**Source:** Leece-Neville Heavy Duty Systems Division – Arcade, NY

**Bulletin No:** TSB-1199

**Subject:** LBP2243GH, LBP2257 to AVI160P2010

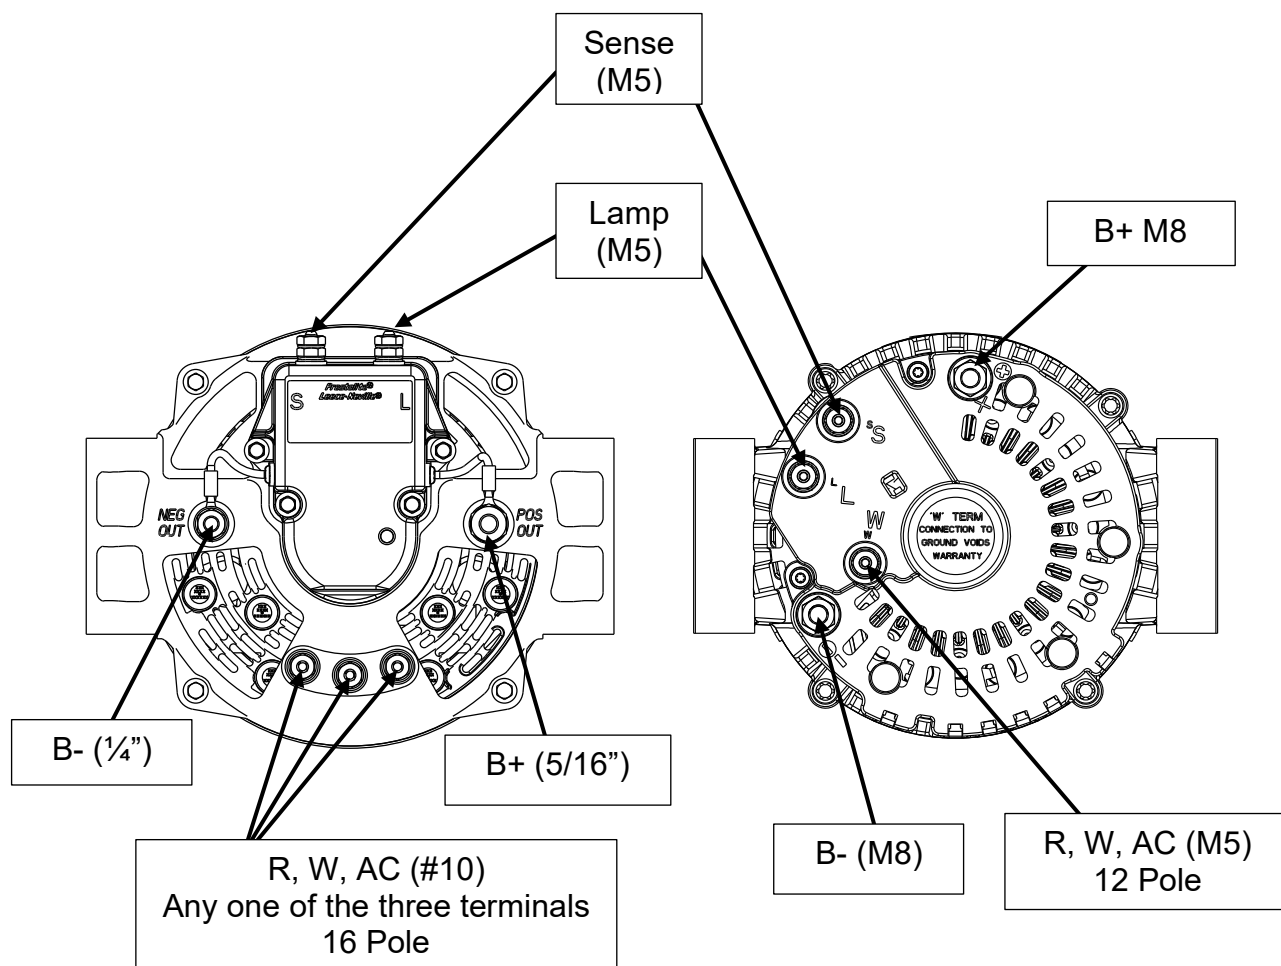
Alternator LBP2243GH and LBP2257 is discontinued and replaced by AVI160P2010.

Both LBP2243GH, LBP2257 and AVI160P2010 are self-excited and insulated return machines.

Note: AVI160P2010 have internal cooling fans. External fan used on the LBP2243GH and LBP2257 is not needed.

This document will help identify terminal location variances.
